# Product Change Notification

<b>Change Notification #:</b>	<b>11117-00</b>
<b>Change Title:</b>	<b>Intel Ethernet Server Adapters I340-T2, I340-T4 &amp; I340-F4, E1G42HTG1P20/E1G44HT/E1G44HTBLK/E1G44HTG1P20/ E1G44HF/E1G44HFBLK/E1G44HFG1P20 (Bartonville DT/QT/QF OEM generic/Retail)</b>  <b>PCN 11117-00</b>  <b>Label</b>  <b>OUI block change</b>
<b>Date of Publication:</b>	<b>November 14, 2011</b>

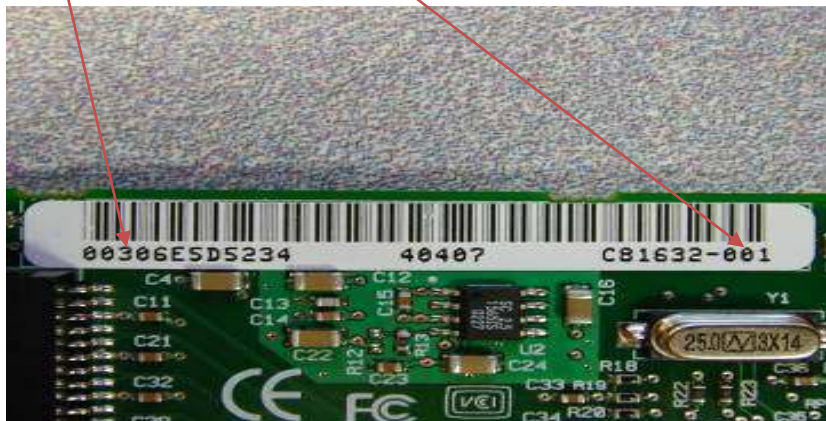
**OUI Block change:** Past run rates have caused the available blocks of MAC addresses assigned to run out. The OUI Block 00-1B-21 has hit the low water mark, the new OUI Block will be 90-E2-BA.

As a result of this change, the PBA (printed board assembly) and TA (top assembly) numbers will roll as noted in the affected products table within this PCN notice. If the PBA/TA numbers are printed on any product or box labels, those will show the PBA/TA dash roll as well.

**3n1 label change:** The 3n1 label will change to reflect the new OUI Block number and PBA# dash roll (printed board assembly), as show in the picture below. The 3n1 label is placed on the Front side of the Printed Board. (picture example only)
